Horizon Utilities Corporation
2015 – 2019 Custom IR Application
EB-2014-0002

Board Staff Interrogatories

Figure 77 - Horizon Utilities Renewal Investment Profile

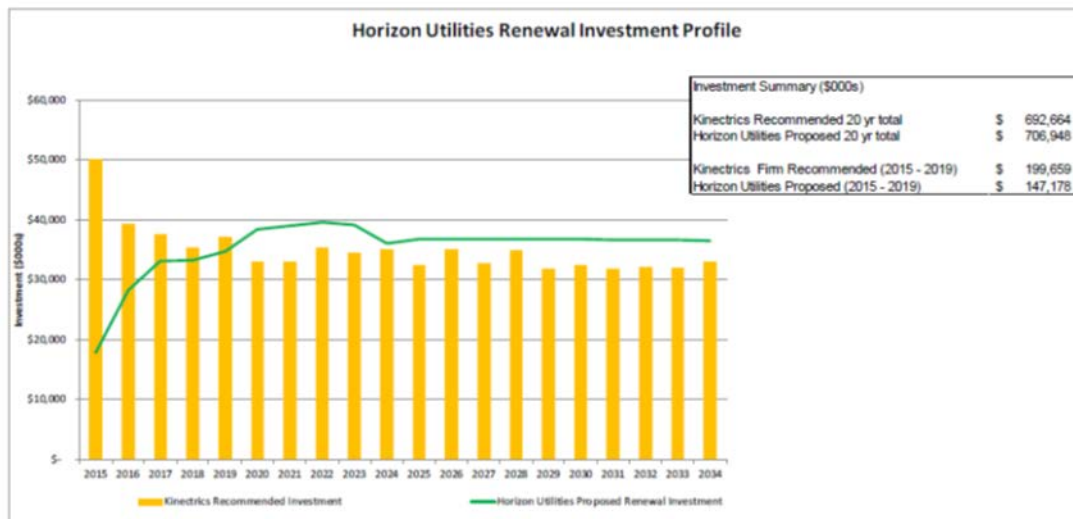
- d. Figure 77 shows that Horizon is only partially following the Kinectrics ACA recommendations.
 - i. Please indicate what required system investments identified by Kinectrics were abandoned and/or delayed to a later stage.

- ii. Please state the priority levels these projects scored.
 - iii. Please explain any remaining Horizon deviations from Kinectrics’ recommendations.

Figure 8: Comparison of Estimated Value of Flagged-for-Action Plans between Kinectrics and KPMG

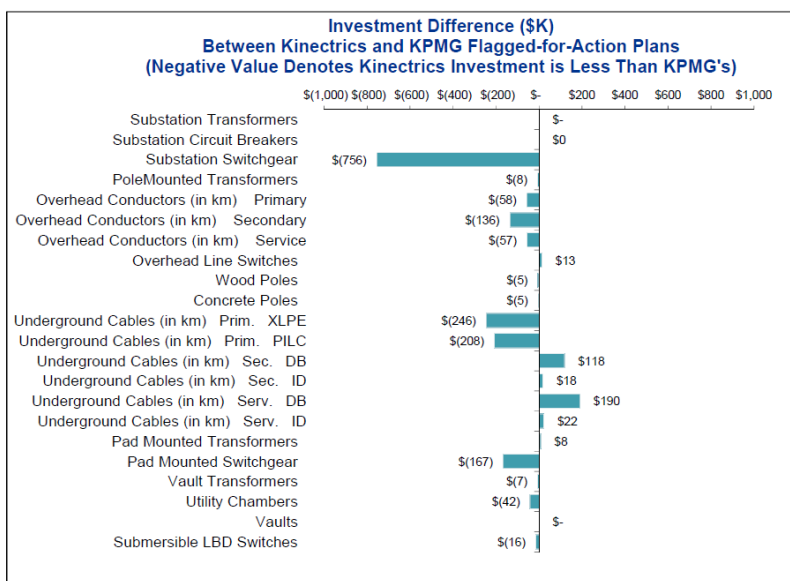
- a. Does the DSP contain an economic evaluation component indicating what the most cost effective actions are for the various categories identified in Figure 8 of the KPMG Report shown above? If so, please point to where this is reflected in the evidence.
- b. Please submit the standard unit costs used in the determination of the Flagged-for-Action investment plans.
- c. Please comment on the investment difference between Kinectrics and KPMG Plans, and whether the lower investment considerations in KPMG's assurance review were incorporated and taken into account by Horizon in its final DSP. If not, why not? Please use the Substation Switchgear asset category and discuss how adopting KPMG's number would alter the current DSP.
